**Re: Response to Heritage Council Comments, IDA/2019/009
Residential Aged Care Facility
Closebourne House, Morpeth**

Residential Aged Care at Closebourne House, Morpeth - IDA/2019/009

ATTACHMENT 1 - Table responding to Heritage Council Advisory Committee comments

PROPOSED DESIGN CHANGES IN RESPONSE TO HCAC CONSIDERATIONS

DRAWING: PLAN CHANGES- GROUND FLOOR (OPTION 1)

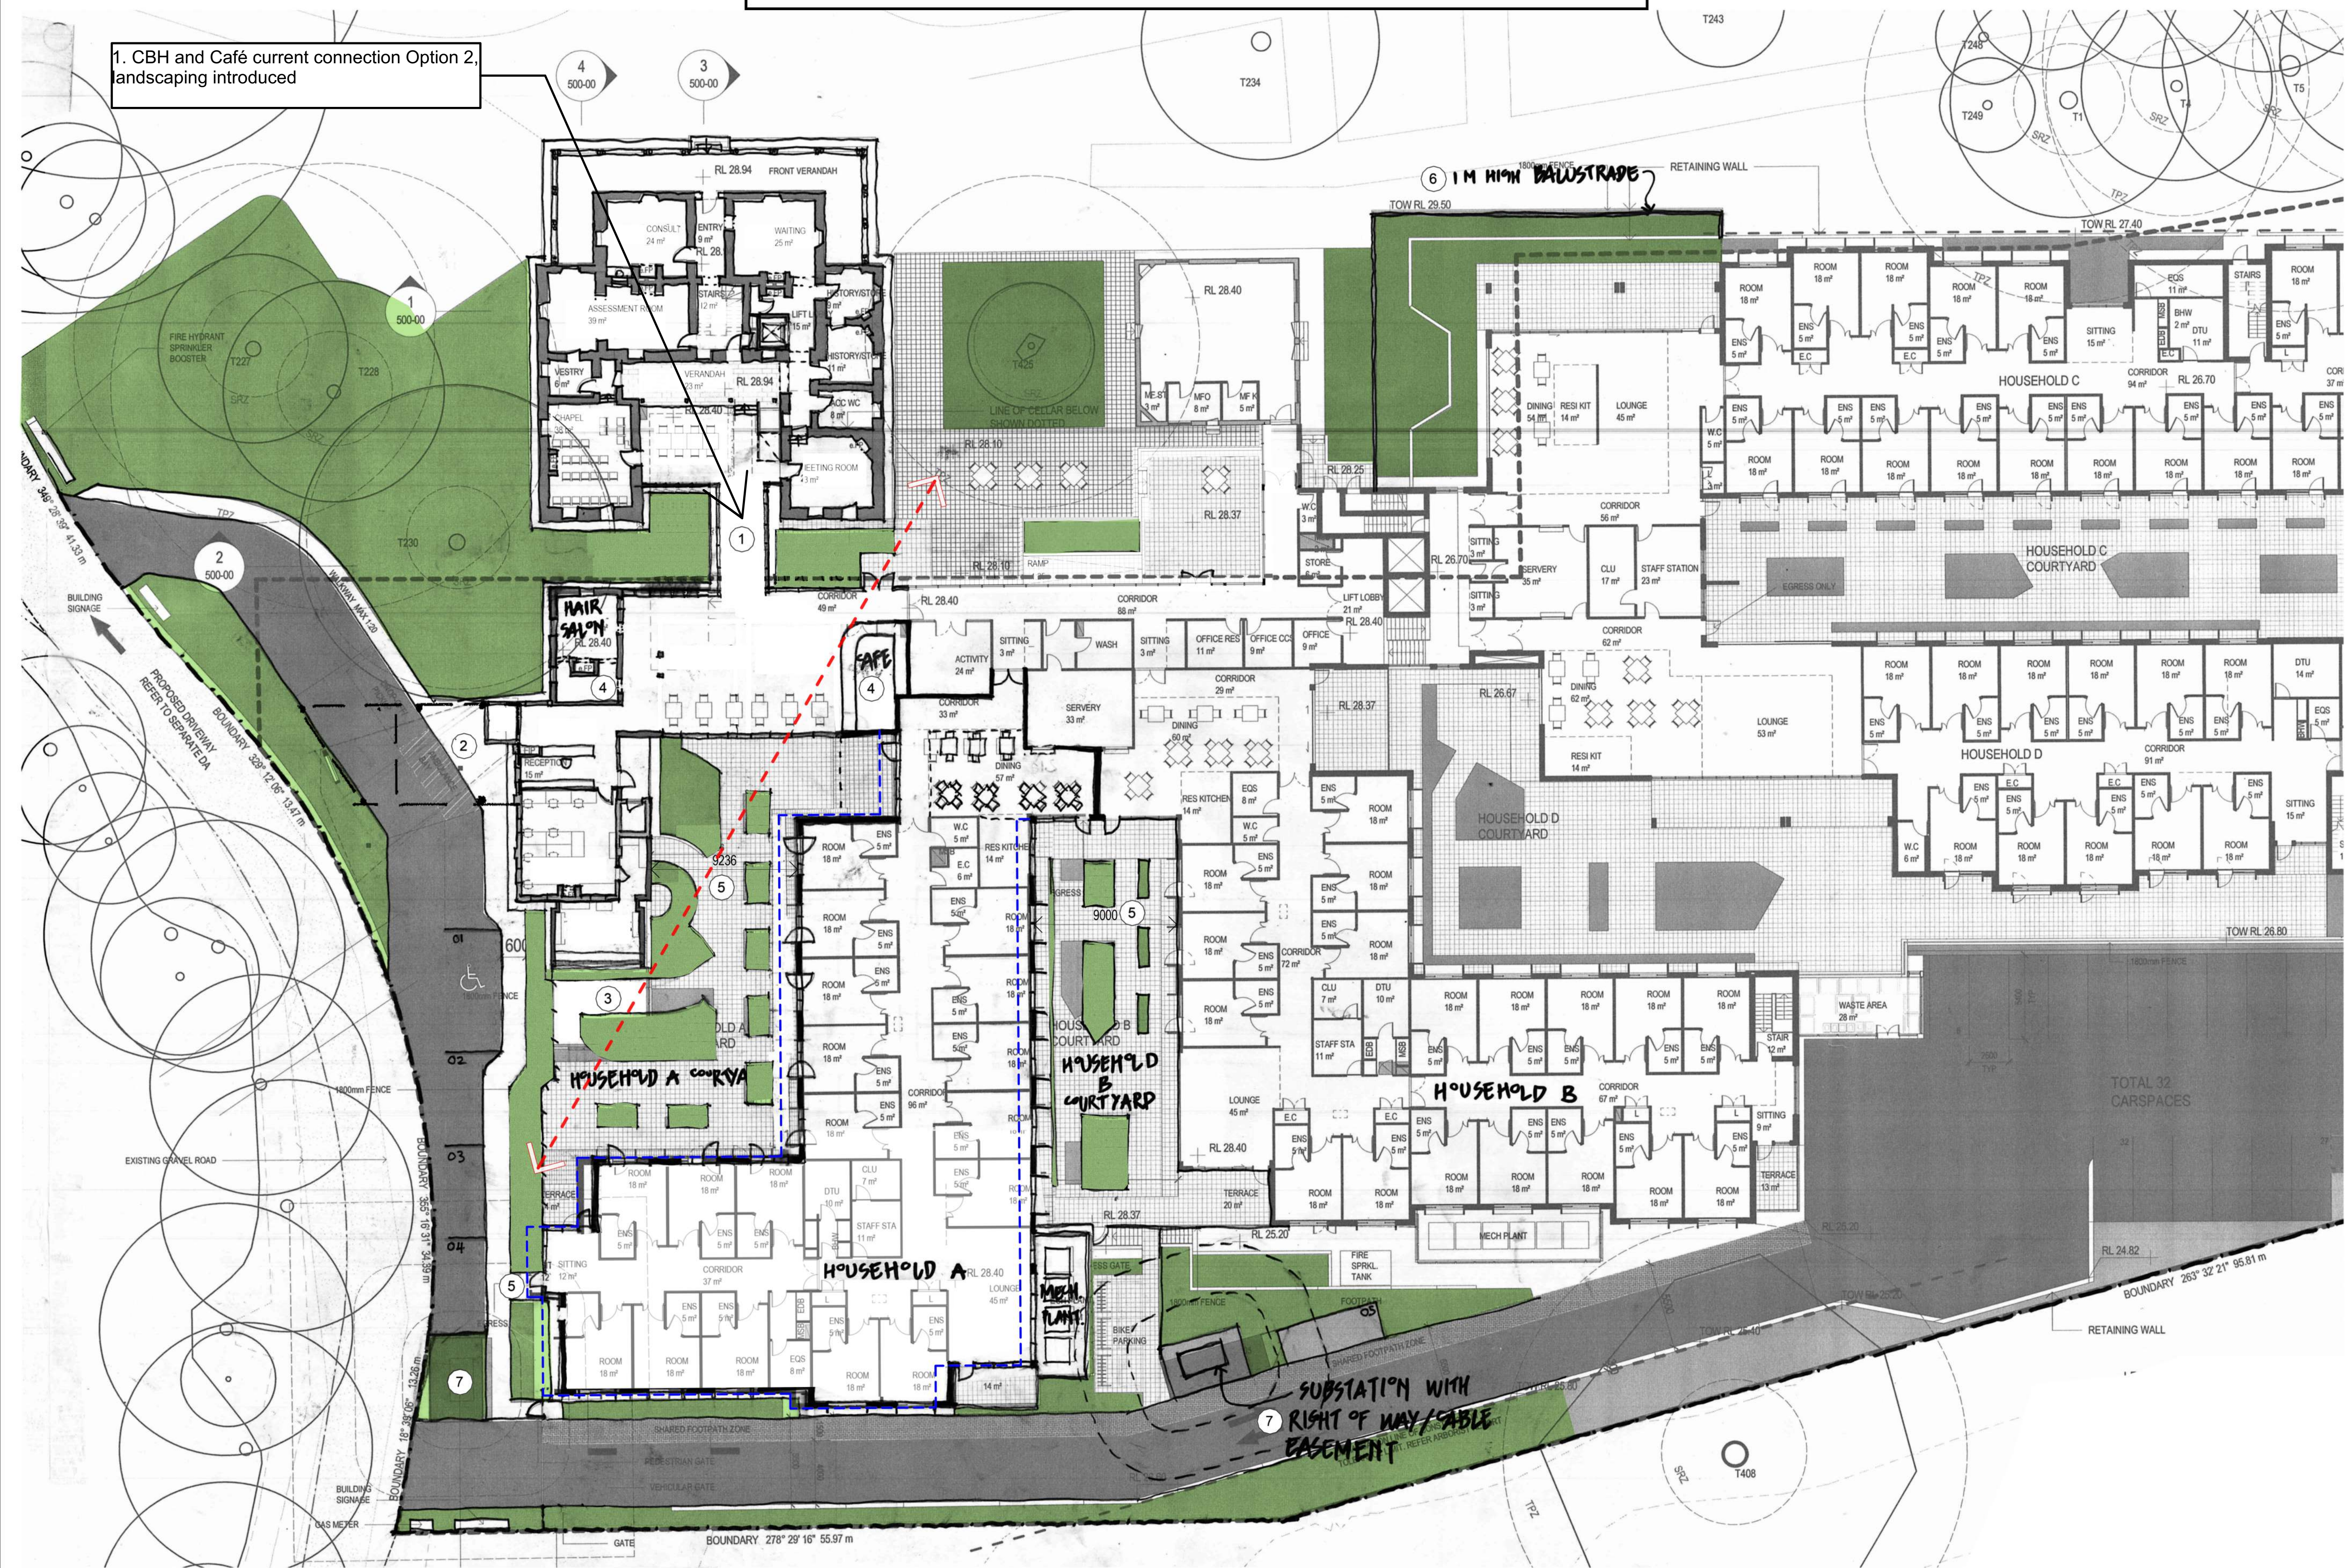
Approvals Committee comments	Proponent response/revisions
1	<p>Connections to CBH</p> <p>Connections of the new building to Closebourne House (CBH) need to be reconsidered, including connection to the courtyard</p>	<p>Response: See attached sketch plans with the suggested revisions to this connection.</p> <p>Background: Noting discussions of 20th March that the weather protected connection is essential for the adaptive re-use of Closebourne House for aged care, these revisions retain this connection while further minimising its impact via 2 options, as follows:</p> <ul style="list-style-type: none"> - <i>Option 1 - centres the connection within the CBH rear courtyard</i> <ul style="list-style-type: none"> - This option provides symmetry of the connection, equidistant between rear wings; - Provides for a landscaped connection adjacent to each rear wing; - Some Bishops stretch foundations will need to be incorporated into the design. - <i>Option 2 - retains the connection on the eastern side of the CBH rear courtyard</i> <ul style="list-style-type: none"> - This option provides a direct alignment with the existing veranda stairs to the rear of CBH and the adjacent platform lift - The Bishops Stretch foundations are more intact/apparent <p><i>For both options:</i></p> <ul style="list-style-type: none"> - Increases the landscaped area at the rear of CBH; - Enhances the green view between CBH and laundry building, when viewing CBH from the west; - As discussed in more detail below, internal rooms in the new adjacent building have been swapped (hairdresser and café) with the café now open plan, enhancing the views/visual connections between the courtyard east of the laundry/gym to the rear of CBH <p>Suggested GTA condition: Add to the following draft condition in the HNSW report:</p>

3	<p>Porte Cochere</p> <p>The scale, form and location for the Porte Cochere needs to be reconsidered. Consider if entrance to RACF can be relocated</p>	<p>Response: See attached sketch plans with revisions to the Porte Cochere, including:</p> <ul style="list-style-type: none"> - Simplified form and lower pitch with significantly reduced prominence, bulk and scale; - This provides for better views to CBH and the laundry/gym buildings; - A minimal, low pitch only which allows for run-off; - Roof extends over the ambulance drop-off area only; - A void extends for the remainder of the structure; - Better respects views of CBH and the laundry building. <p>Suggested GTA condition: Add to the following draft condition in the HNSW report:</p> <p>3. Details to be submitted for approval with the S60 application <i>Amended architectural drawings to reduce the scale, form and location of the Porte Cochere; generally as demonstrated in sketch plans submitted on 25 March 2020</i></p>

4	<p>Plant/substation</p> <p>The separation of plant and utility room from the rear of the former gym needs to be considered, as does the substation near Household A</p>	<p>Response: See attached sketch plans with the suggested revisions to relocate the substation and two options for relocating the Condensers as follows:</p> <ul style="list-style-type: none"> - Substation to be relocated from street front to a discrete location in the southern elevation of the new building, adjacent to the rear of building and car park access; - Condensers to be relocated from street front/adjacent to former gymnasium building with 2 options for a discrete part of the new building roof, which would not be visible from the surrounds, including: <ul style="list-style-type: none"> - Option 1 - east of courtyard on roof level/flat roof area below the roof pitch - Option 2 - Household B roof area sloping towards the south <p>Suggested GTA condition: Add to the following draft condition in the HNSW report:</p> <p>3. Details to be submitted for approval with the S60 application <i>Amended architectural drawings to relocate the substation and options for the location of the condensers; generally as demonstrated in sketch plans submitted on 25 March 2020</i></p>

<p>5</p>	<p>Café</p> <p>Reconsider the Café size, scale and location. Consider possibility of locating inside CBH</p>	<p>Response: See attached sketch plans with revised location of the café as follows:</p> <ul style="list-style-type: none"> - Relocate café from laundry building, switching with hairdressers' room - Café redesigned for an open plan within the new building, to maximise views within and between the courtyard and the rear of CBH. - (Note that a café location within CBH was considered in previous schemes and was rejected as requiring much greater intervention than the currently proposed uses) <p>Suggested GTA condition: Add to the following draft condition in the HNSW report:</p> <p>3. Details to be submitted for approval with the S60 application <i>Amended architectural drawings to relocate and reconfigure the café within the new building; generally as demonstrated in sketch plans submitted on 25 March 2020</i></p>

<p>7</p>	<p>Amend development footprint</p> <p>Consider whether overall start of development footprint can align with eastern wall of CBH</p>	<p>Response: See attached sketch plans with revised footprint as follows:</p> <ul style="list-style-type: none"> - The new building (Household A) has been moved east by approx. 1m - Increased set back of Household A to the street front, which enhances the prominence of the former gymnasium/laundry heritage buildings. - This courtyard south of CBH is increased, with increased landscaped area - The courtyard is better connected with CBH with a wider view corridor (which is further improved given the above-mentioned café relocation within the building) - The 9m wide courtyard (reduced from 10m) at Household B, retains its amenity <p>Suggested GTA condition: Add to the following draft condition in the HNSW report:</p> <p>3. Details to be submitted for approval with the S60 application <i>Amended architectural drawings to move the new building footprint to the east; generally as demonstrated in sketch plans submitted on 25 March 2020</i></p>

1. CBH and Café Connection Option 1, connection centred and landscape introduced

4. Cafe/Hair Salon switched location, allows wall to be removed & open up view corridor

6. 1.8m fence replaced with 1m high balustrade

2. Porte Cochere redesigned to a lighter, simplified roof structure and reduced extent. Refer roof plan and sketch 3d views.

3. Condensers moved from rear of Chapel/ Gym to roof area on House A, refer options on roof plan

5. Household A shifted 1m to the east to open up courtyard and increased landscape at the approach.

7. Substation relocated from SW corner of site to a discreet location

1 FLOOR PLAN - GROUND LEVEL - CLOSEBOURNE

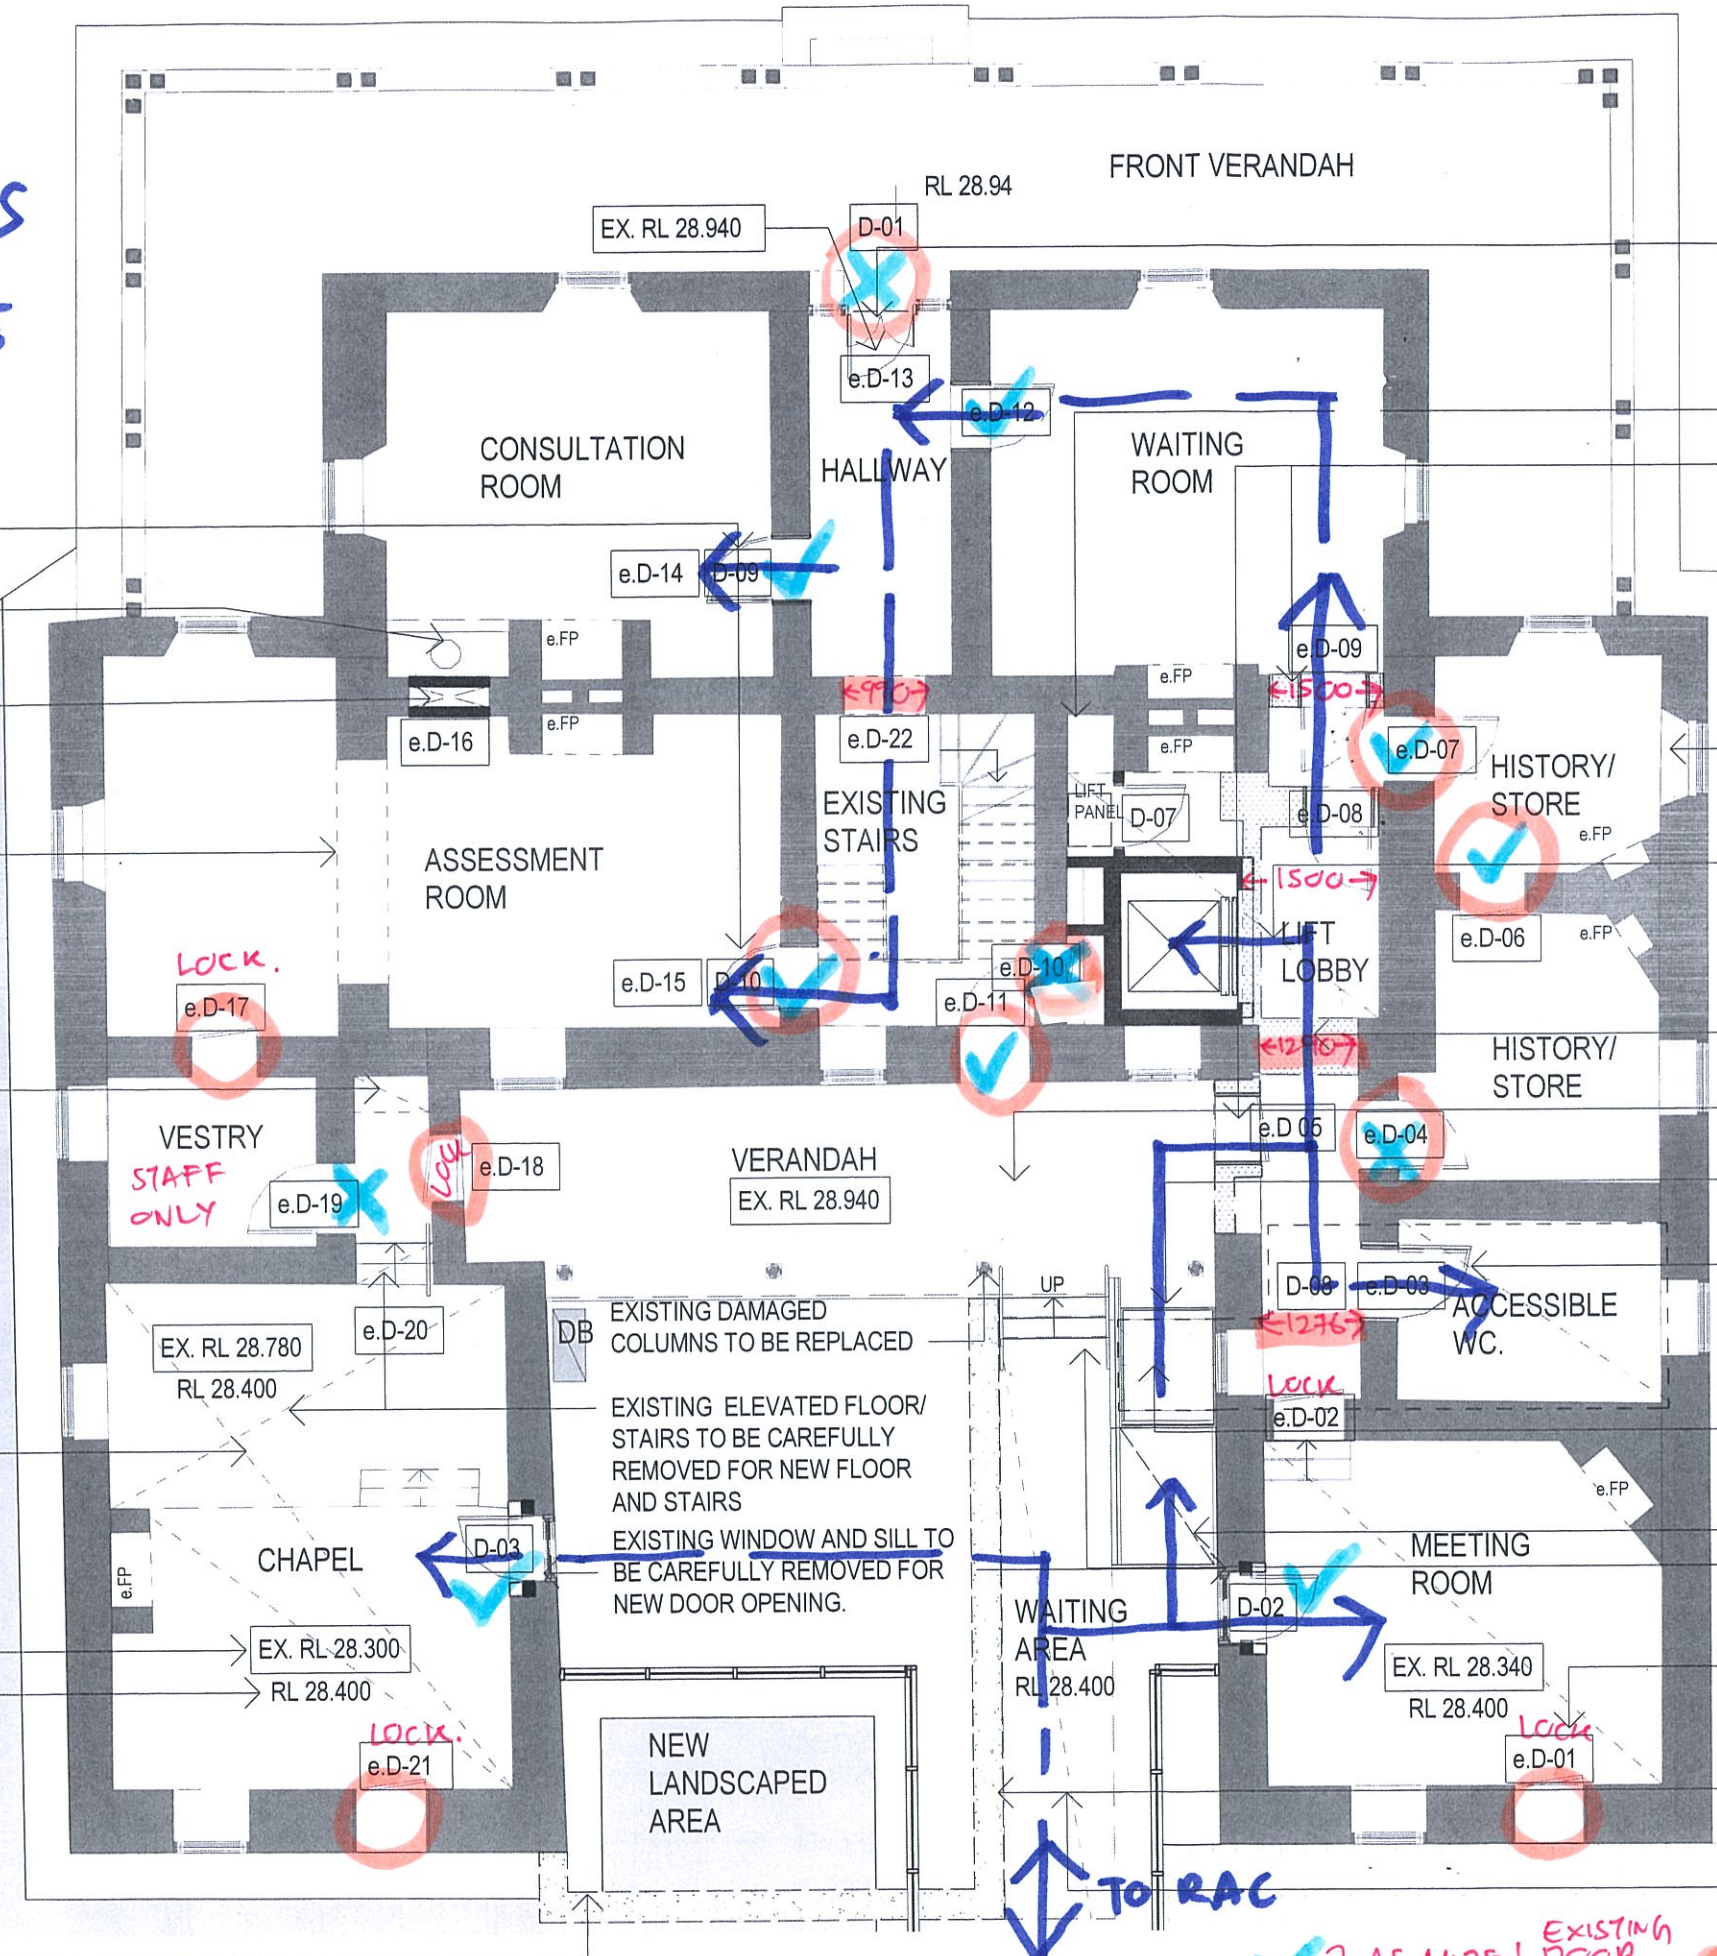
9	Door details Door widening within CBH must be minimised to essential requirements only	<p>Response: See attached sketch plan which demonstrates the single path of accessible travel within CBH. As discussed on 20 March 2020, doorway changes have been minimised so that there is only one path of accessible travel within CBH.</p> <p>Suggested GTA condition: Delete draft Condition 3 (b) and replace with:</p> <p>3. Details to be submitted for approval with the S60 application <i>Details of the door widening to be confirmed for essential accessibility requirements only; generally as demonstrated in sketch plans submitted on 25 March 2020</i></p>
10	Skylights Skylights in rear wings of CBH are acceptable	<p>Response: noted</p> <p>Suggested GTA condition: <i>Delete draft condition 3(a) in the HNSW report</i></p>
11	Fence Fence adjacent to Arkell House must be redesigned	<p>Response: See attached sketch plan with revisions as follows:</p> <ul style="list-style-type: none"> - reduction of 1.8m fence to 1m - this retains safety/security from the internal courtyard or externally which slopes away from Arkell House - minimal and reduced impact on Arkell House <p>Suggested GTA condition: Replace Condition 3 (r) in the HNSW report with:</p> <p>3. Details to be submitted for approval with the S60 application <i>Details of the amended fencing adjacent to Arkell House to be provided; generally as demonstrated in sketch plans submitted on 25 March 2020</i></p>

CORRIDOR WIDTH LESS THAN 1.5M BCA D1.6 (b)(iii)(A)

UNOBSTRUCTED HEIGHT OF DOORWAY LESS THAN 1980MM BCA D1.6(a) DOOR TO BE LOCKED INDEFINITELY

EXISTING DOORS TO BE CAREFULLY REMOVED AND REPLACED WITH NEW COMPLYING DOORS

EXISTING BI-PARTING DOOR TO BE CAREFULLY REMOVED AND REPLACED WITH NEW SINGLE LEAF EGRESS DOOR
